MEMORANDUM

(301) 495-4572
REVIEW TYPE: **Project Plan Review**
CASE #: **920060050**
PROJECT NAME: **The Rugby Condominium**
APPLYING FOR: Approval of 70 multiple-family dwelling units including
11 MPDU's on .47 gross acres
REVIEW BASIS: Sec. 59-D-2, Montgomery County Zoning Ordinance
ZONE: CBD-1
LOCATION: North Side of Rugby Avenue at the intersection of
Auburn and Rugby Avenues; 300 feet east of Norfolk Avenue
MASTER PLAN: 1994 Sector Plan for the Bethesda CBD
2006 Woodmont Triangle Amendment to the
1994 Sector Plan for the Bethesda CBD
APPLICANT: 4851 Rugby Avenue, LLC
FILING DATE: August 29, 2005
HEARING DATE: June 22, 2006
PREVIOUS HEARINGS: March 30, 2006, June 22, 2006

RUGBY CONDOMINIUMS

PROJECT PLAN #920060050
July 20, 2006

Proposed 101 Foot Building – Front Facade

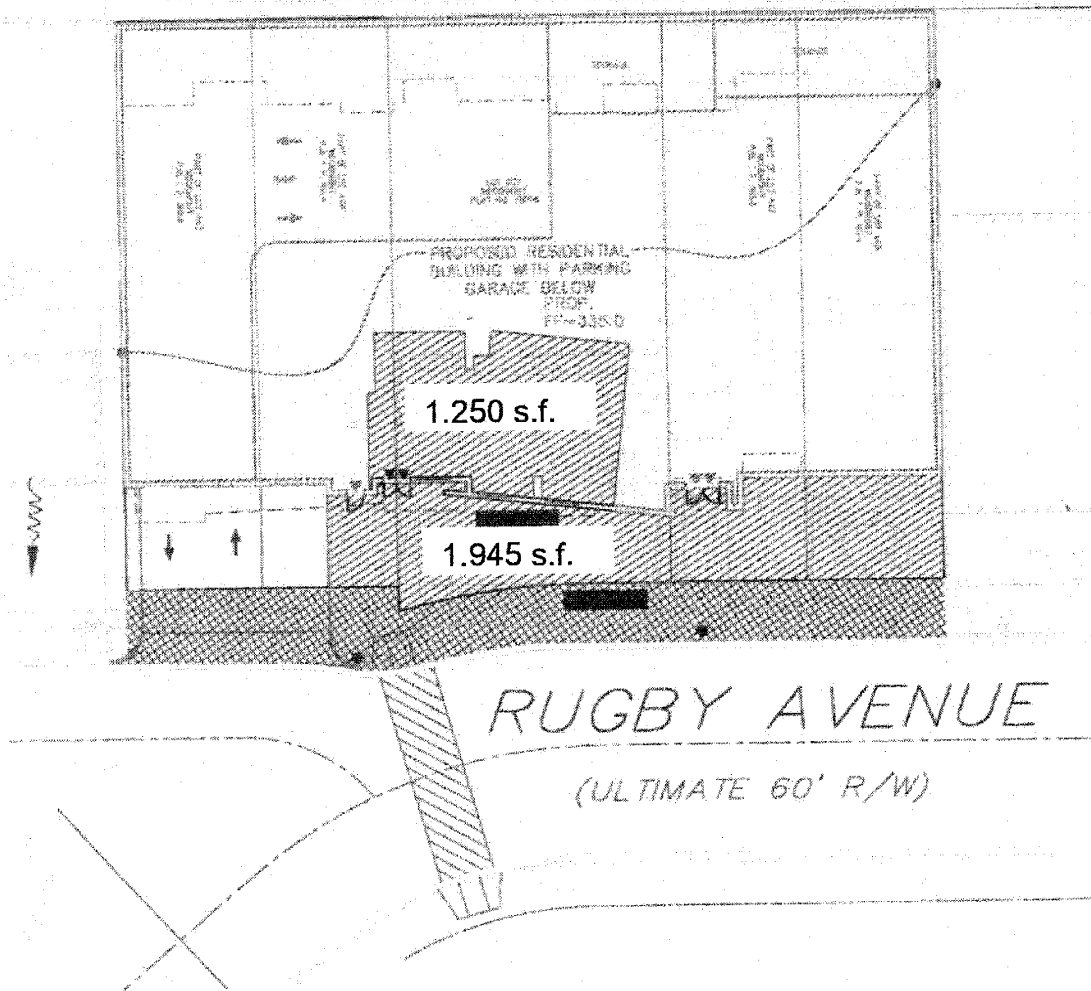
The proposed Project Plan is **not** in accordance with the Approved and Adopted 1994 Sector Plan for the Bethesda Central Business District and the 2006 Wisconsin Triangle Amendment to the Sector Plan approved by the County Council and adopted by the full Park and Planning Commission on March 15, 2006. The 1994 Sector Plan and the Amendment call for a step down in height at the north end of the CBD.

The proposed development consists of a 101-foot high, 10-story residential condominium building containing 71 dwelling units. Under the 1994 Plan, a maximum height of 50 feet was recommended at this location. The 2006 Woodmont Triangle Amendment limits projects to the maximum height allowed in the zone, which, as applied to this proposal, is a maximum of 90 feet. To approve a height of 90 feet, the Planning Board must make a finding that the project does not adversely impact the surrounding properties. See Attachment #1, Section 59-C-6.235 (b) of the zoning ordinance.

This project plan would accomplish certain Sector Plan and Woodmont Triangle Amendment objectives by providing more housing, MPDUs on site, and a Facility Plan for the Battery Lane Urban Park. However, it cannot be approved at the proposed height, which exceeds the maximum height permitted under the zone.

The proposed project would begin a revitalization of Rugby Avenue east of Norfolk Avenue and contribute to the supply of residential choices in the Bethesda CBD. Height over 90 feet would not create a desirable relationship between the site and the R-10 existing multi-family apartments to the northwest.

The 4851 Rugby Avenue project proposes additional residential units for the edge of the CBD. 90 feet is the maximum recommended height at the edge of the CBD for compatibility with the adjacent land uses, existing 3-5 story

- a. The Applicant can resubmit a proposal at 90 feet with 20% public use space on or off-site, if it can be proven that 20% can not be provided on site while providing 15% MPDUs on site, and an amenity package representing between 40 and 60 per cent of their net lot area.
